New Castle Planning and Zoning Commission (Regular Meeting)

A. R2 Castle Valley Ranch Multifamily Sketch Plan Application

Staff Report

**Castle Valley Ranch PA 8 & 9
Sketch Plan
Planning Commission – October 25th, 2023**

Illustrative Site Plan

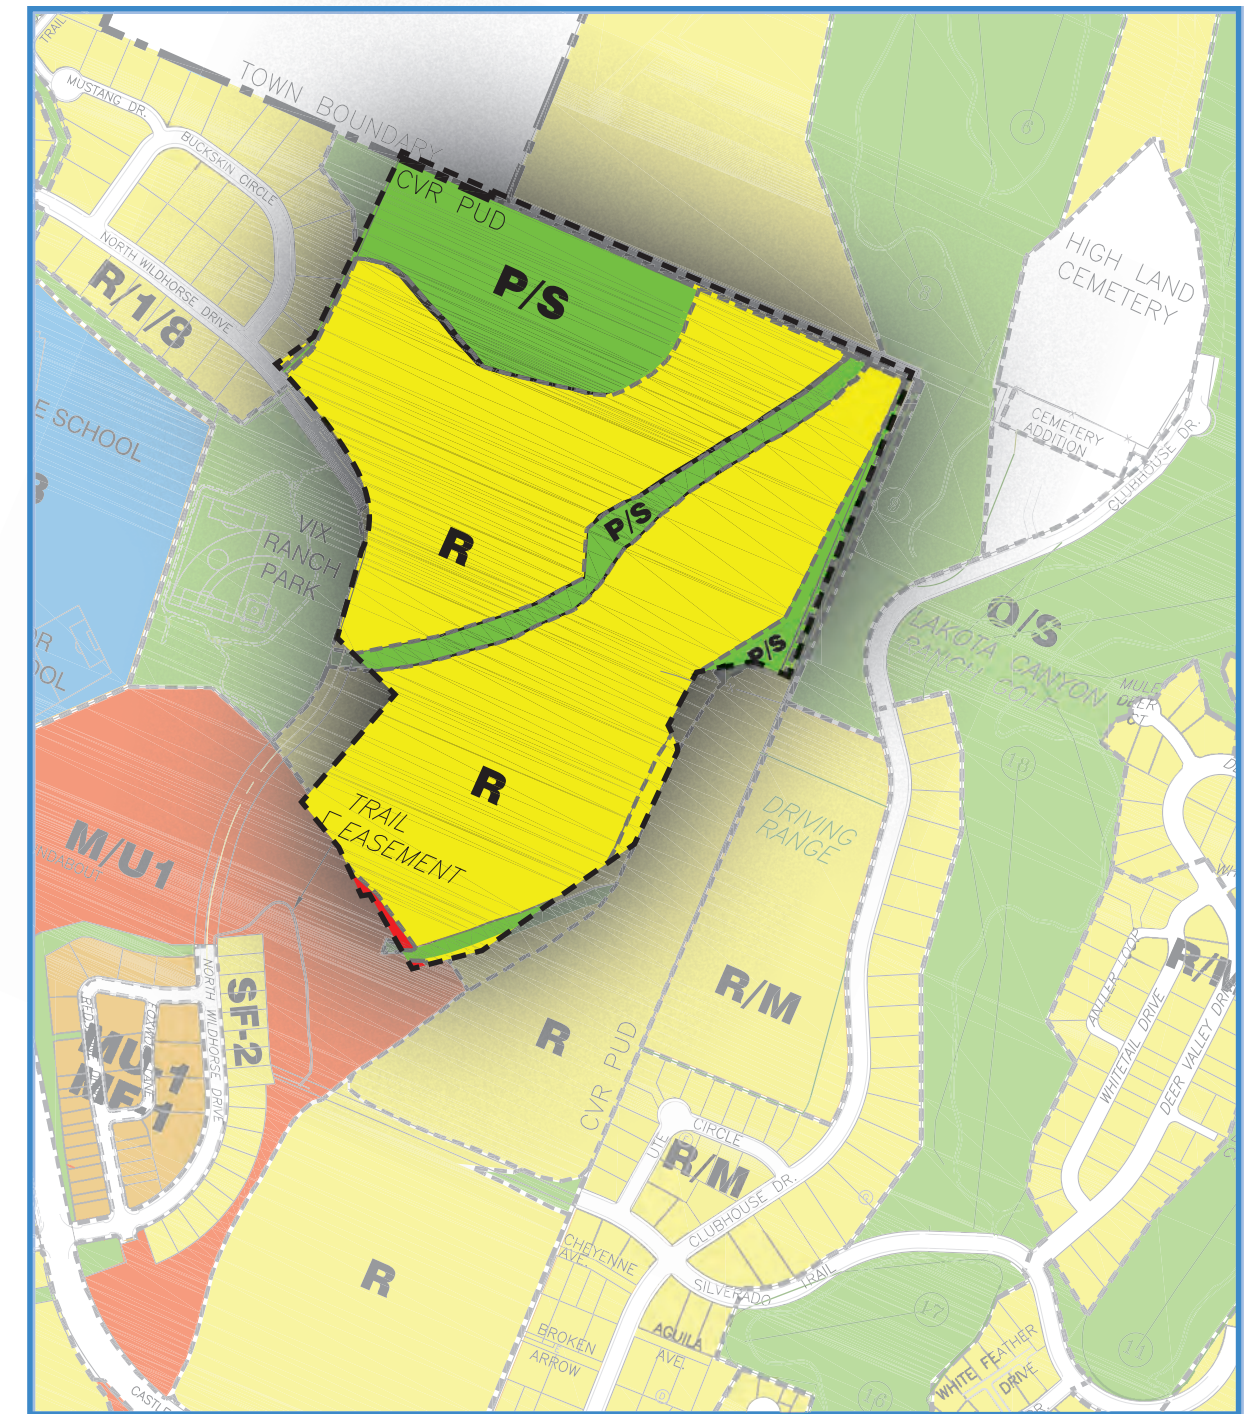
Open Space: As mentioned, the Applicant has made efforts to integrate existing public use trails and fields into the development’s open space plan (**Exhibit A, page 14**). Small, active parks are provided in two locations interior to the development in both the northern and southern halves. All proposed open space and natural trails, implied as Town wide amenities, should be identified on the plat as Town maintained. Interior trails, pocket parks, or courtyards meant solely for tenant use should be maintained by the HOA.

Trails Planning

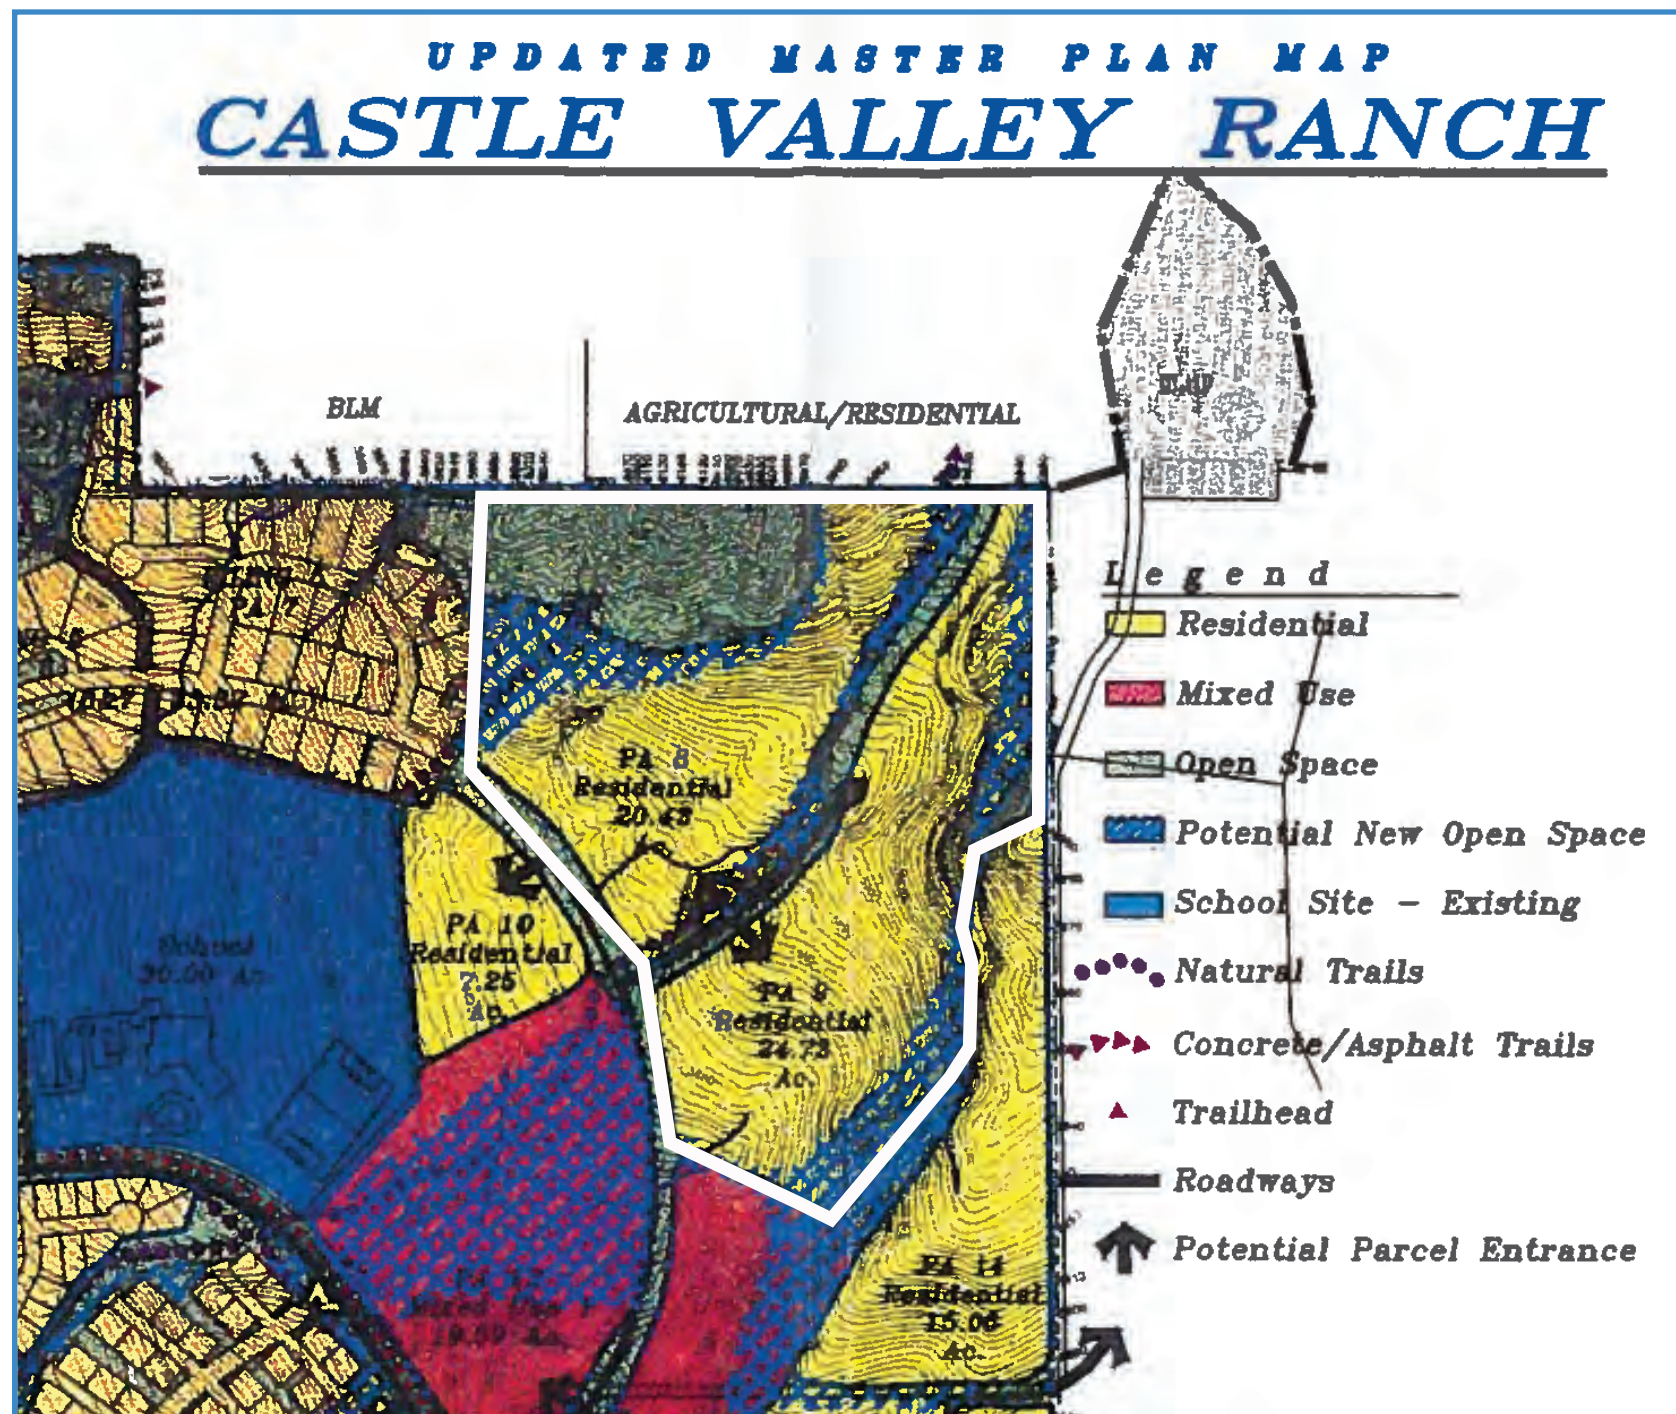
Trails/Open Space/Recreation: The trails map on **Exhibit A, page 17** demonstrates a certain level of fidelity with currently existing use-trails and trail agreements. Two trails will originate from VIX Park and lead east towards the locally named "Sunset Trail that ultimately connects with public lands. This alignment already exists. The goal is for a seamless trail experience with trails already prized by residents (**Goal POST-3**). Preservation of the Sunset Trail corridor should also be supportive of existing wildlife habitat (**Goal POST-4**). Other walking trails are dispersed within the development's interior. Taken together the trail network will be conducive to non-vehicular access to adjoining neighborhoods and specifically the future mixed-use development.

Typical Right-of-Way Conditions

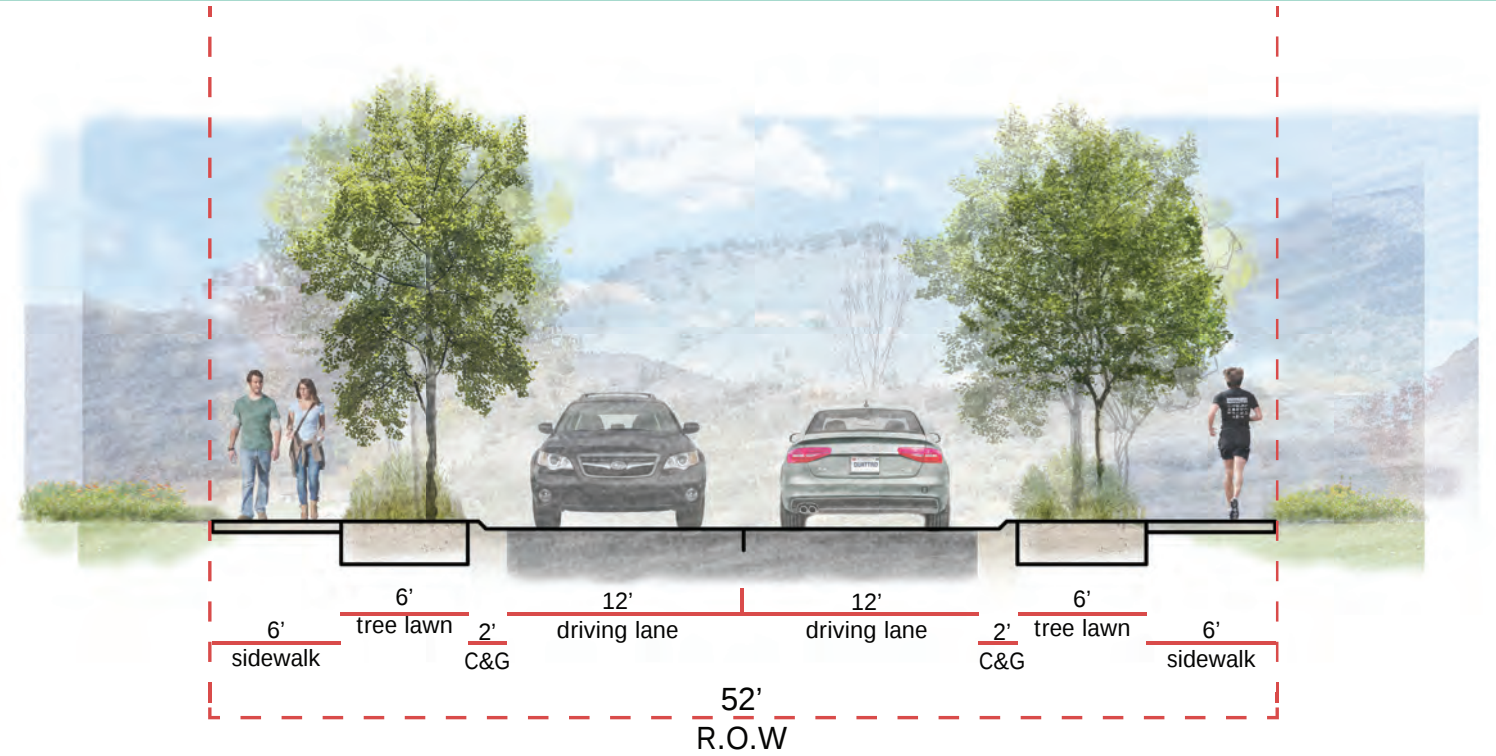
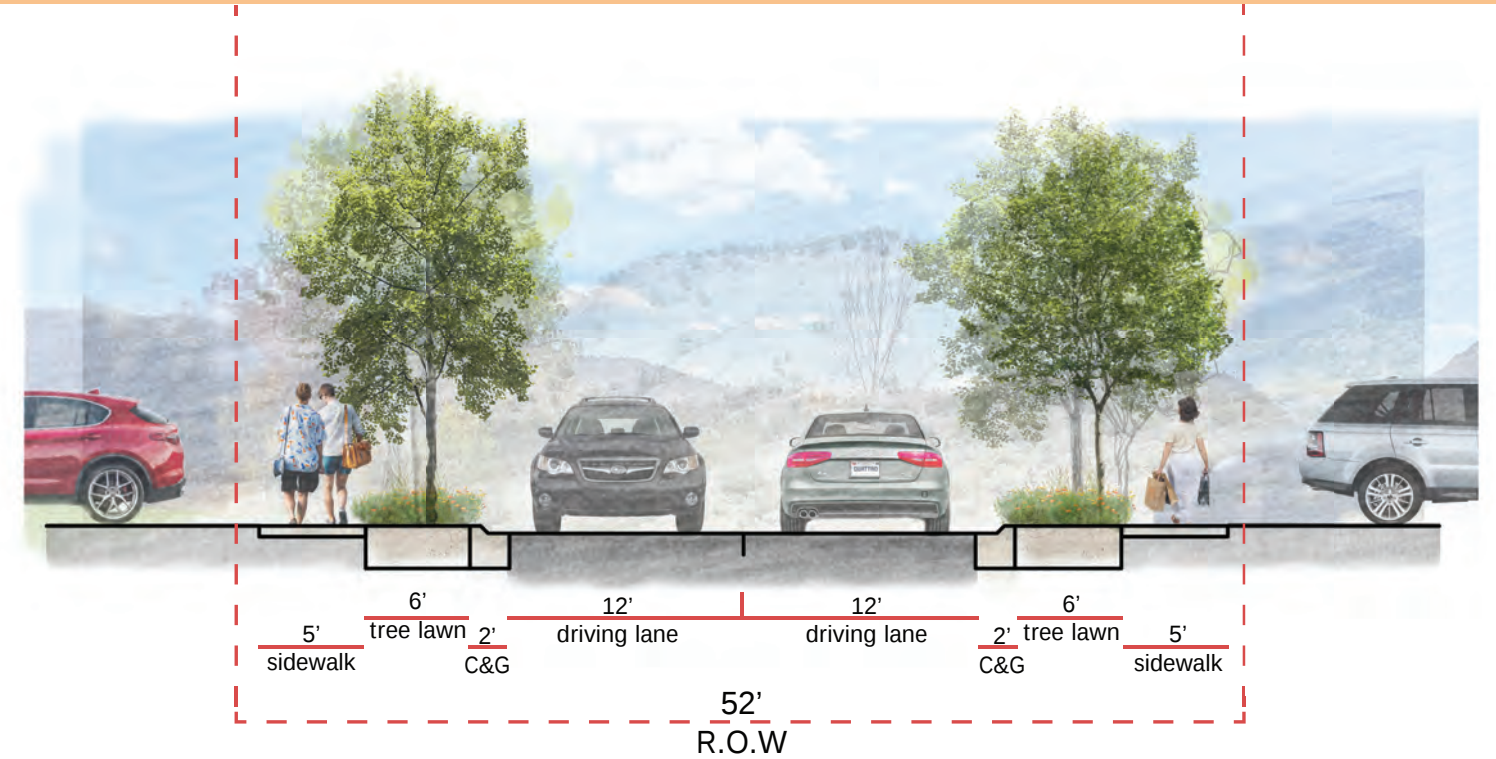
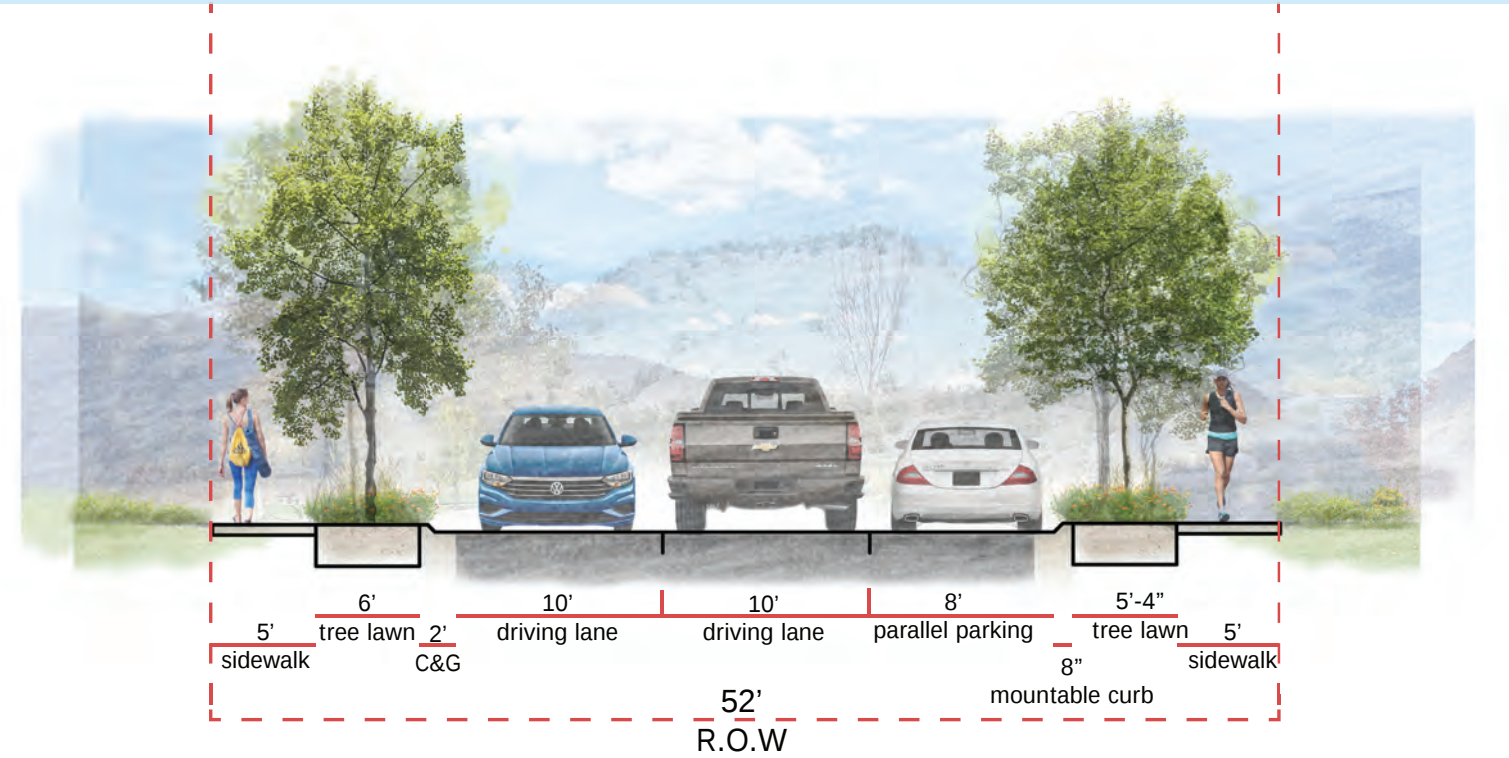
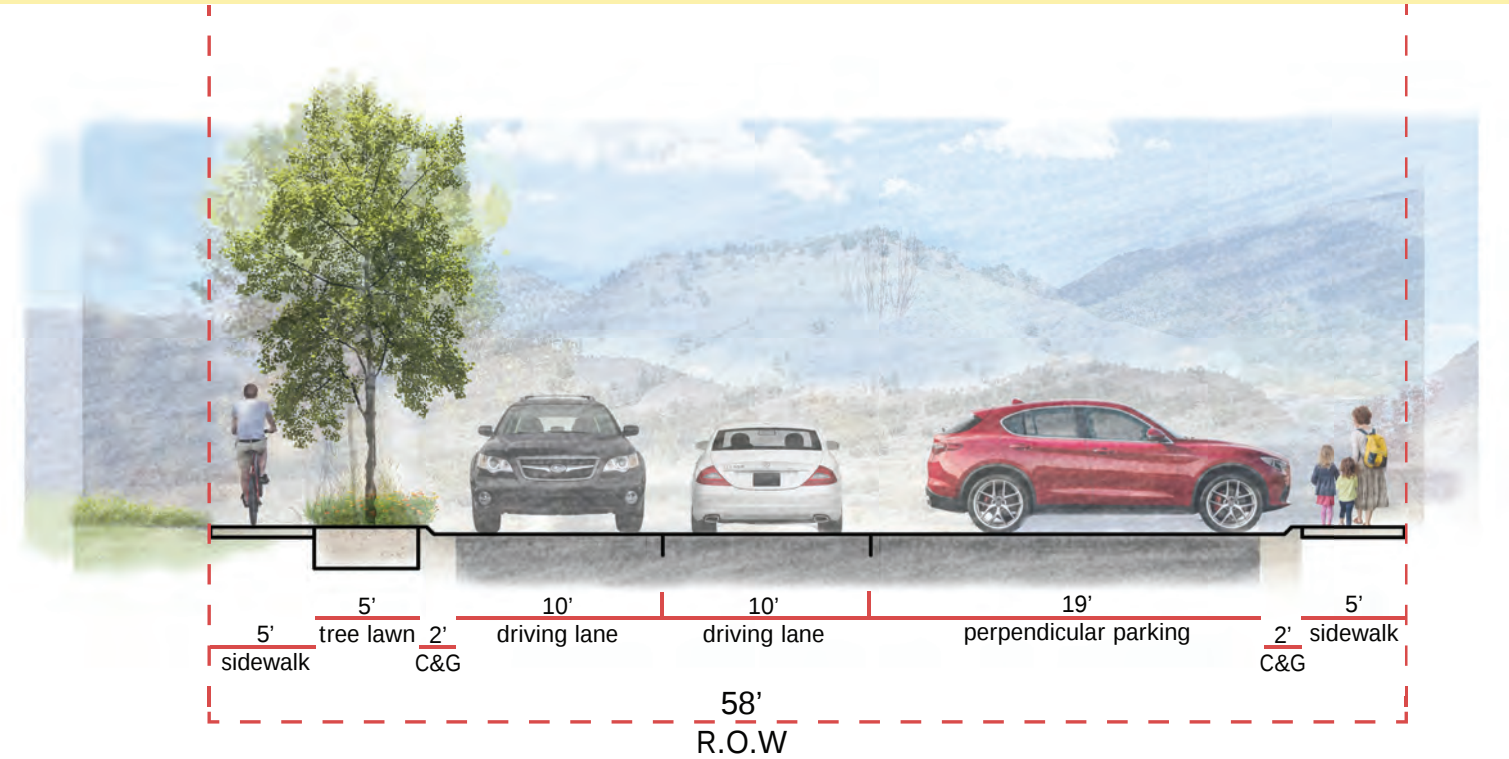
- A. To better preserve safety, traffic flow, and general quality of life, revise public rights-of-way shown on Exhibit A, page 19 as follows:

- Teal ROW – no change requested.
 - Peach ROW – modify to meet the Town’s 58’ design cross-section.
 - Blue ROW – modify with on-street parking along one side of ring-road.
